**ADDENDUM TO THE
TECHNICAL DRAINAGE STUDY
FOR
DUNCAN LEON COMMERCIAL**

**Date
March 1, 2021**

**Project Number
20-0014**

Subject: Addendum to the Technical Drainage Study for Duncan Leon Commercial
(CLV No.: 5417)
(APN 138-12-110-051)

FIGURE 5

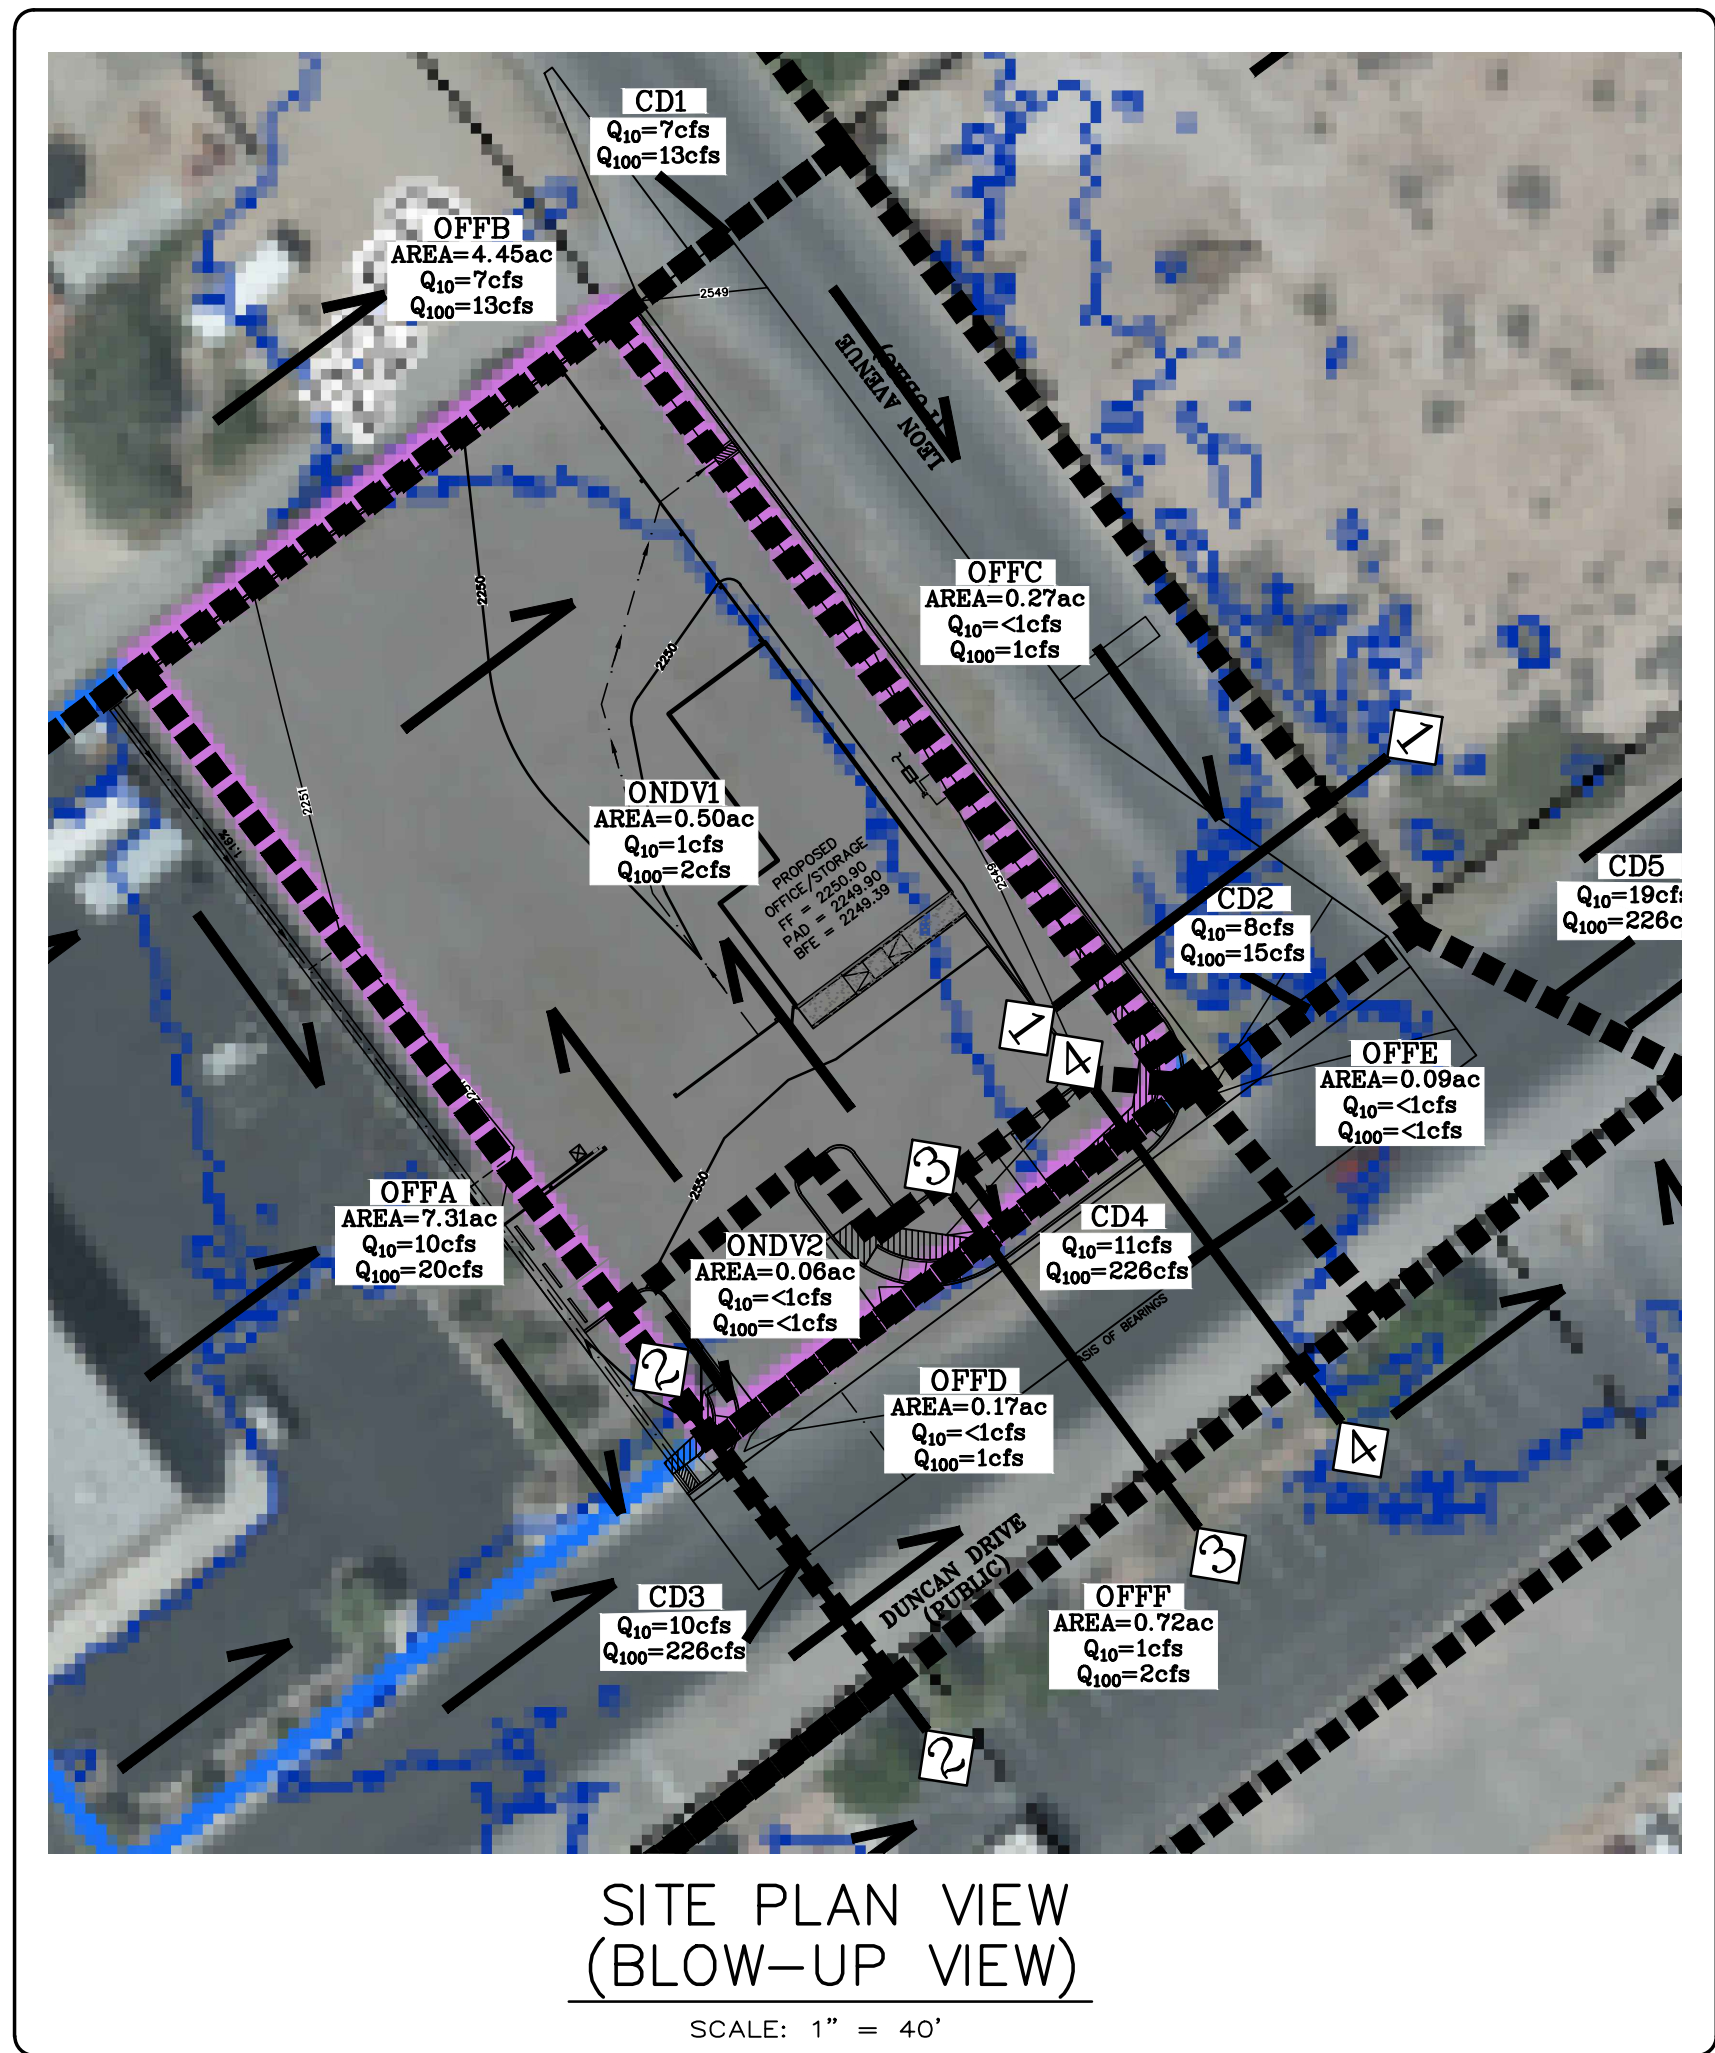
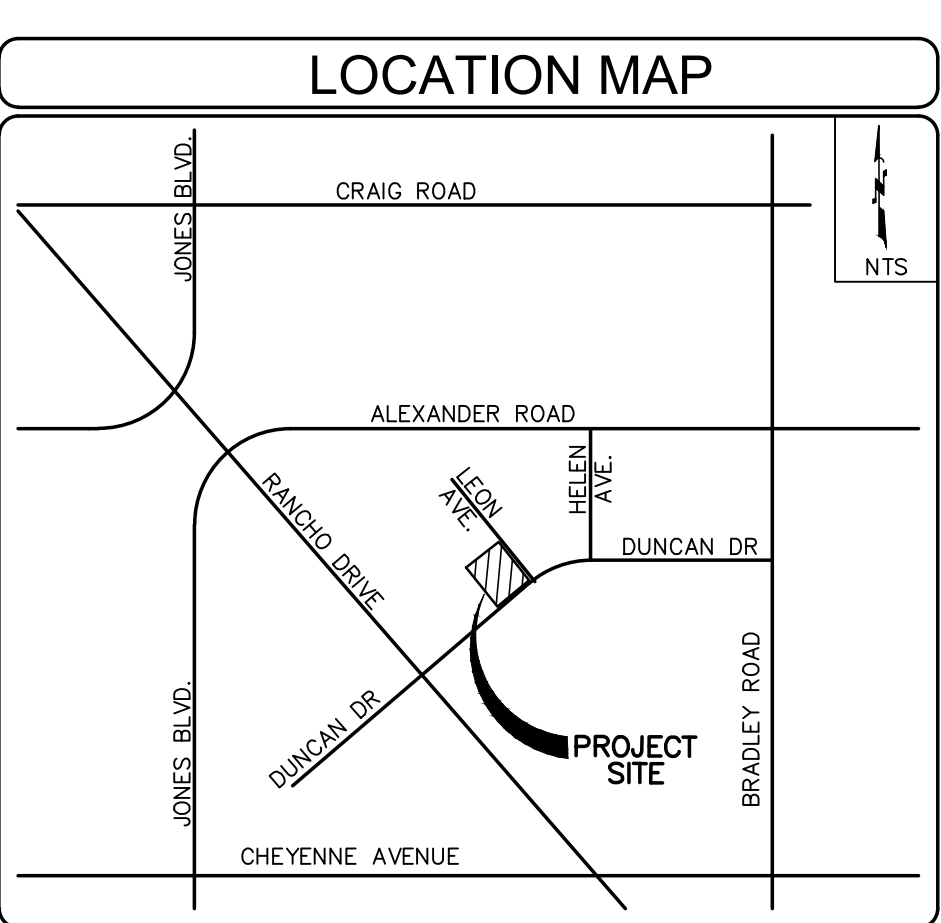
7. Update Figure 5 & 6 to reflect the 206 cfs at the Rancho Intersection and 226 cfs at the site.

Response: Updated Figures 5 & 6 are attached.

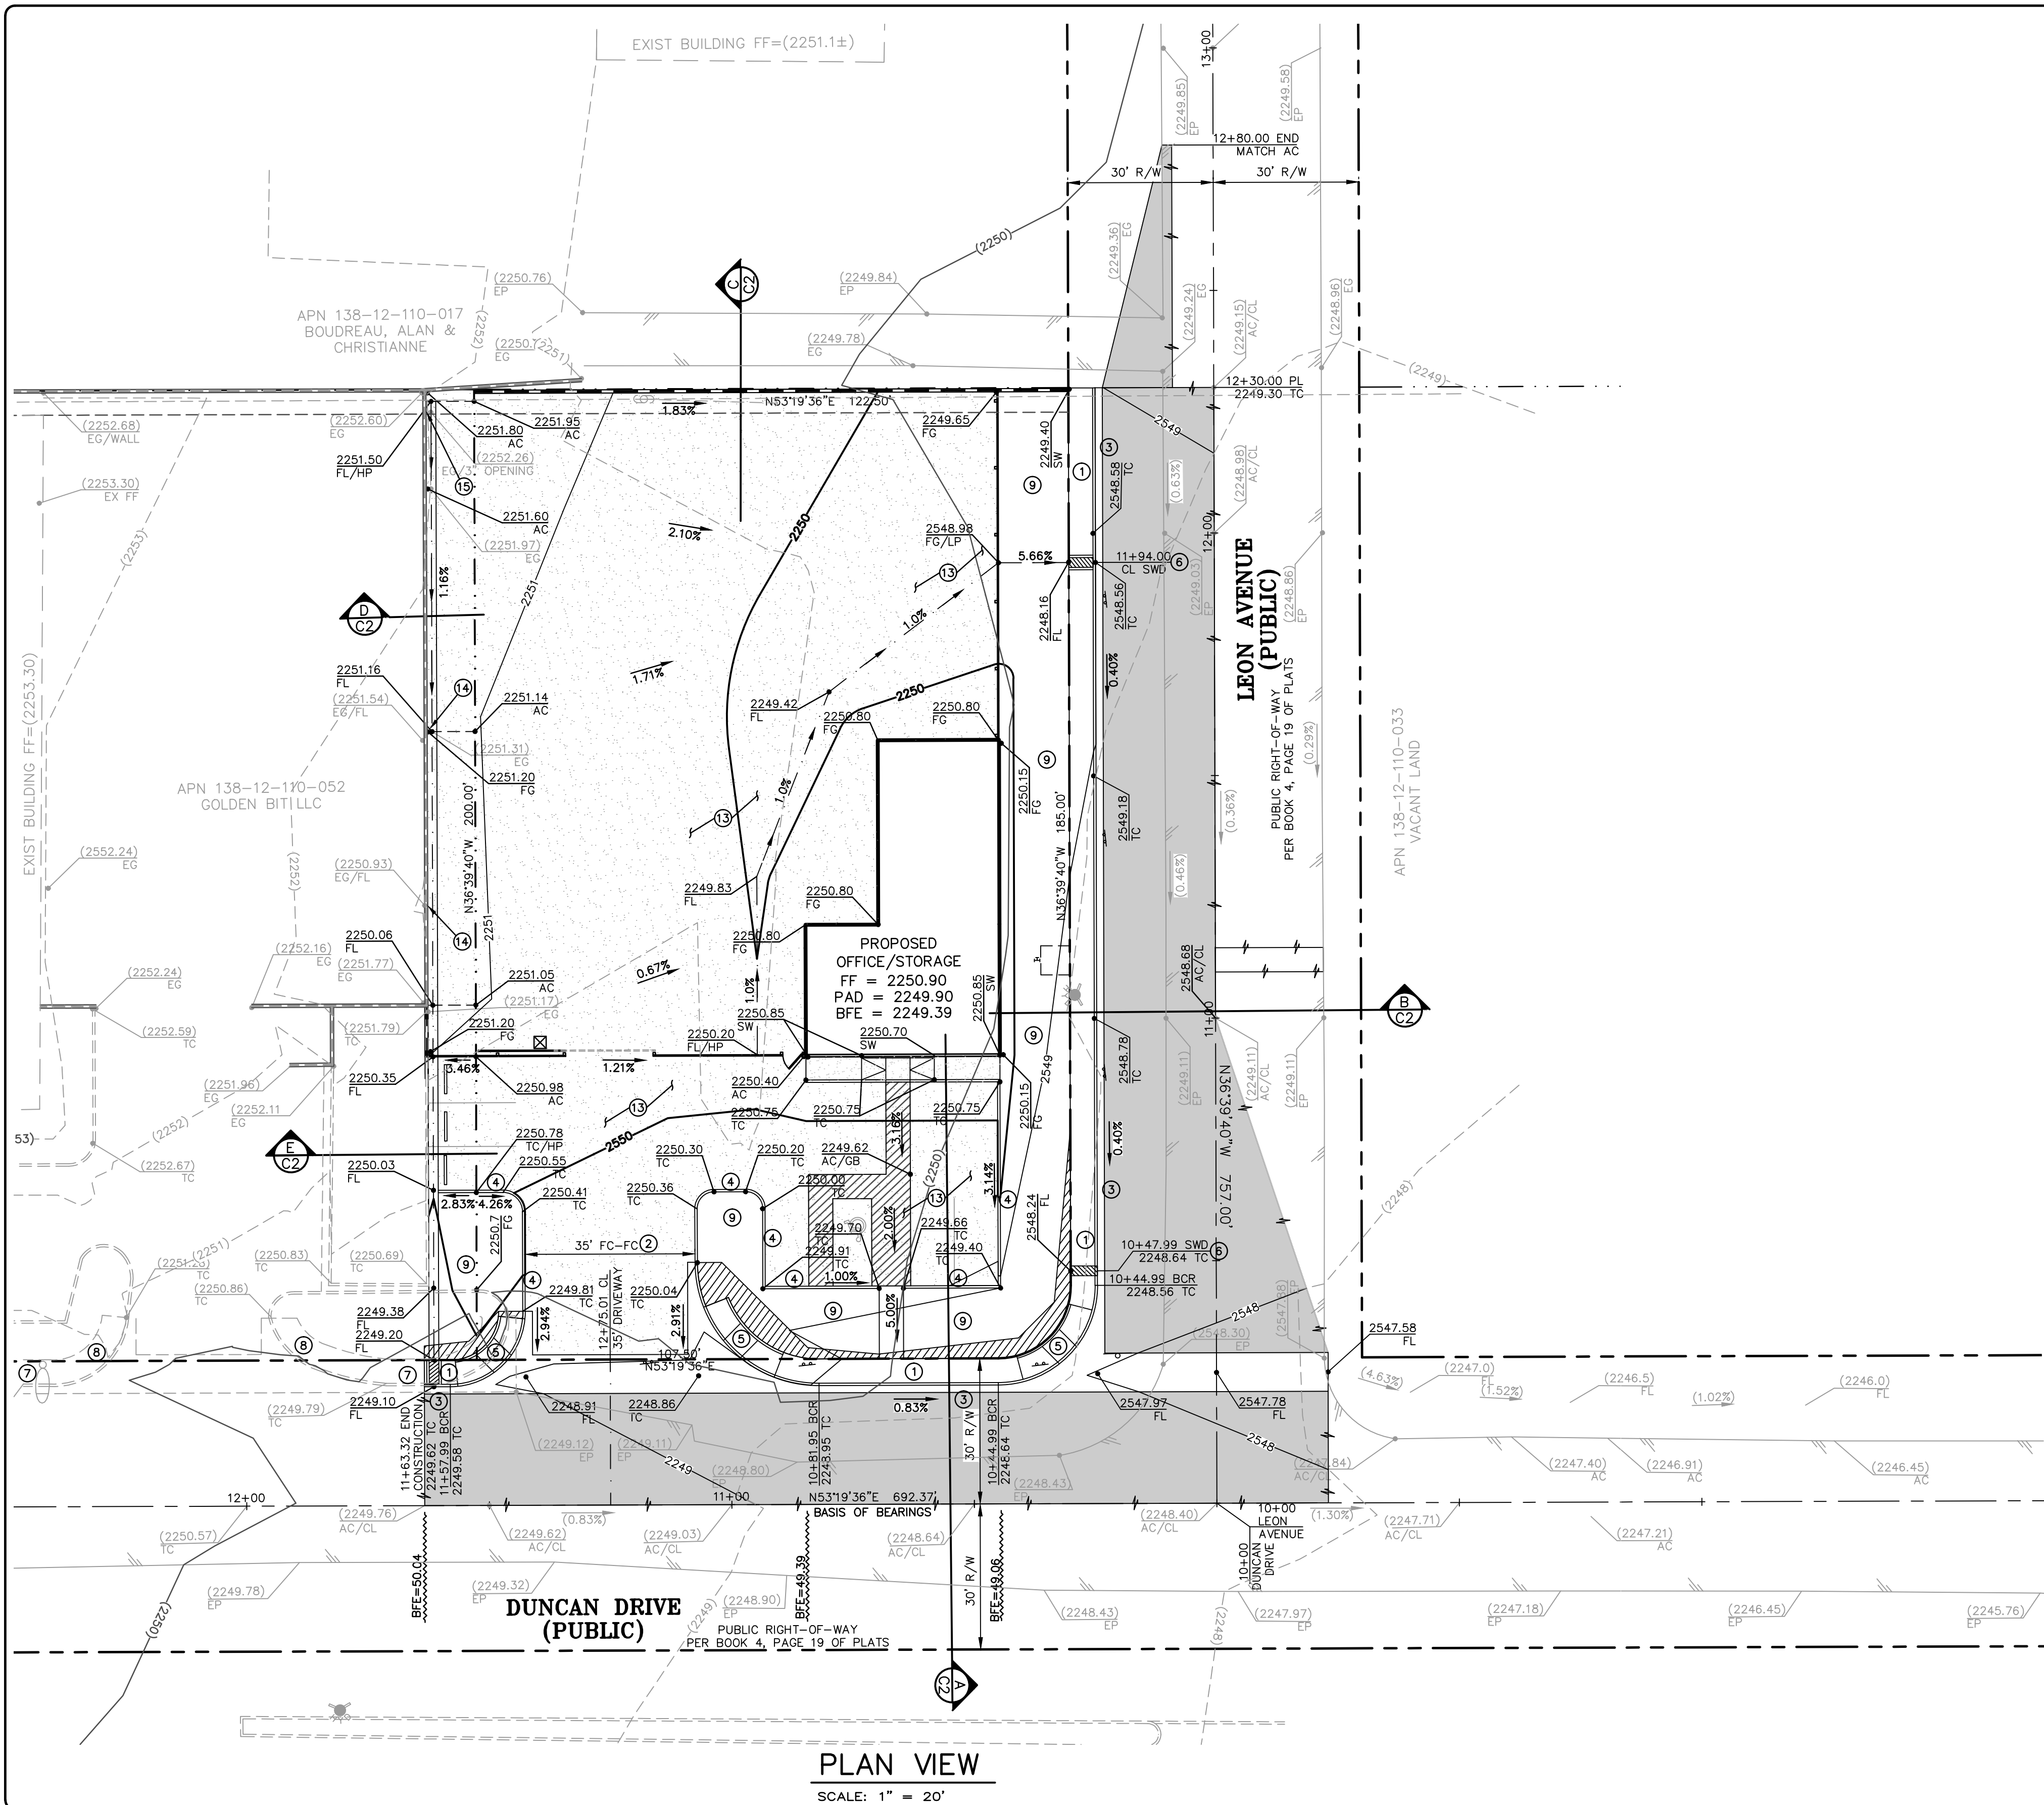
9. Revise the entry and parking lot grading so that the onsite elevations are above the flow depth in the Duncan. The intent is to keep the 100-year flow within the street and out of the site, reducing site impacts.

10. The grading plan needs to show the Base Flood Elevation at the Building.

11. Provide a Public Drainage Easement to be Privately Maintained (site to be privately maintained by the property owner) for the area of the site impacted by the existing Zone A, Flood Zone. All areas of the site not occupied by the proposed Building shall be designated as within the Public Drainage Easement to be Privately Maintained. The easement shall note that the private drainage improvements are privately maintained and the easement must be dedicated and recorded by separate document prior to the final acceptance of the improvement plans. Provide legal description and an exhibit of the drainage easement for Flood Control approval and then submit to City of Las Vegas Right of Way Section for the recordation process after the subject drainage study is conditionally approved.

12. Add a Note to the Grading Plan. All areas of the site not occupied by the proposed Building shall be designated as a Public Drainage Easement to be Privately Maintained.

13. The engineer shall provide a table on the grading plans that shows the quantity estimate of all on-site improvements. All required drainage improvements within the Public Drainage Easement to be Privately Maintained shall be bonded and inspected. The bonded improvements will not be released until the LOMR-F is obtained from FEMA and filed with the City of Las Vegas.

15. Revise the pavement grading to show positive drainage away from the west side of the Building.
Response: The attached revised Grading Plan shows the revised proposed drainage grades along the west side of the proposed building.

16. Show a swale from the parking lot low point out to Leon and include a sidewalk underdrain connection into the street.
Response: The attached revised Grading Plan shows the proposed swale grades.

17. Provide existing swale elevation east of the Duncan Valley Gutter to show positive drainage.
Response: The Surveyor has re-shot elevations along the Duncan Valley Gutter. See attached revised Grading Plan.

18. Verify curb grade and slopes along Leon Ave. Show existing Leon R/W width on plans.
Response: The Surveyor has re-shot elevations along the Leon Avenue curb grades and slopes. See attached revised Grading Plan.

19. Verify the Stationing of the driveway centerline.
Response: The Stationing has been check and revised. See attached revised Grading Plan.

Response: Attached is the revised Grading Plan.

Response: Attached is the revised Grading Plan.

Response: Attached is the revised Grading Plan showing that the whole site except the building will be in a Public Drainage Easement to be Privately Maintained.

Response: Attached is the revised Grading Plan showing that the whole site except the building will be in a Public Drainage Easement to be Privately Maintained.

Response: The attached revised Grading Plan. Shows the table.
14. A portion of the development is shown crossing property lines. Provide Permission to Grade Letter and/or easement for use of adjoining parcel prior to Final Drainage Study approval. An alternative to consider would be a Boundary adjustment.

ALL AREAS OF THE SITE NOT OCCUPIED BY THE PROPOSED BUILDING SHALL BE DESIGNATED AS A PUBLIC DRAINAGE EASEMENT TO BE PRIVATELY MAINTAINED.
